# WHITLEY COUNTY ADVISORY PLAN COMMISSION **STAFF REPORT**

24-W-SUBD-3 PRIMARY PLAT APPROVAL

West Loon

**FEBRUARY 21, 2024**

# WEST LOON (PRELIMINARY

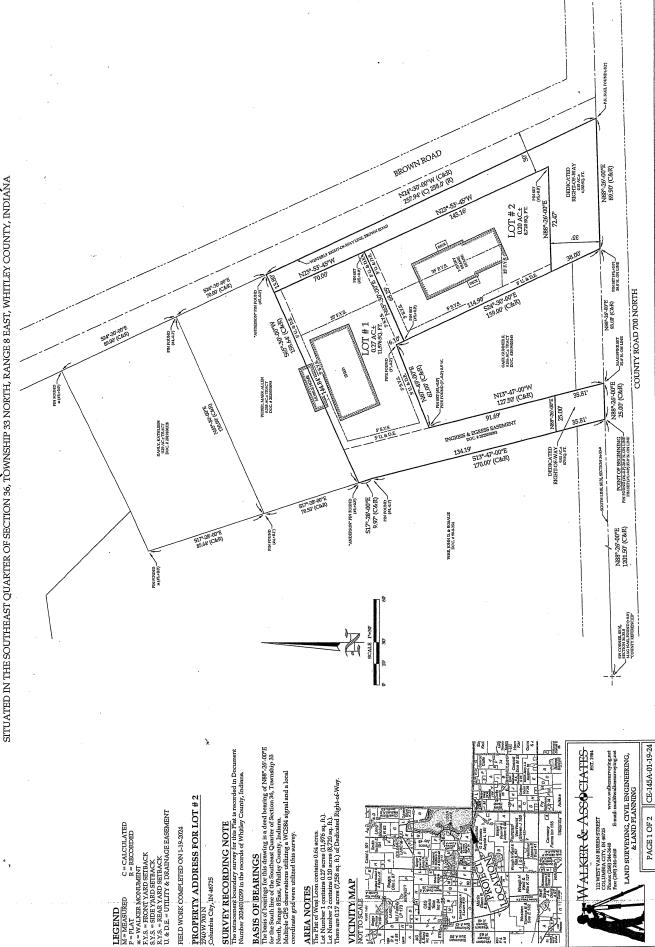
The property has sanitary sewer available. The proposed plat does not comply with the minimum lot size and lot width, as shown in the table above. The petitioner has already filed variance requests for these deficiencies, as well as a variance for the legal nonconforming setbacks. So, approval of this plat would need to be conditioned upon the approval of the variances.

As proposed, a 35' wide ROW would be dedicated along 700 North, while a 30' wide ROW would be dedicated along Brown Road. Both roads are shown on the Transportation Plan as collector roads with future 70' rights-of-way. This reduction in width for Brown Road requires a waiver, discussed below.

10' drainage and/or utility easements are shown on the perimeter of the lots. The existing outbuilding encroaches into the easement and the 10' side yard setback. This is another legal nonconformance that may be addressed as part of the requested variances.

Since the proposed plat creates a new lot that could be potentially used for a residence, the code requires a minimum of 75' of shoreline (50' for the first lot and 25' for the second), which is noncompliant.

The Transportation Map of the Comprehensive Plan designates Brown Road as a minor collector, which is to have a 70' right-of-way width (or 35' ½-width). So, the proposed 30' ½-width for Brown Road is deficient.

- 1. At least one of the proposed lots shall no longer be a grantee of the access easement recorded as Instrument #1991050245. The petitioner must record an instrument documenting this rescission, or similar documentation.
- 2. The requested waiver of right-of-way width is granted as presented, with the suggested findings.
- 3. Variances for the lot area and lot width must be obtained.
- 4. Secondary plat approval delegated to the Plan Commission Staff.
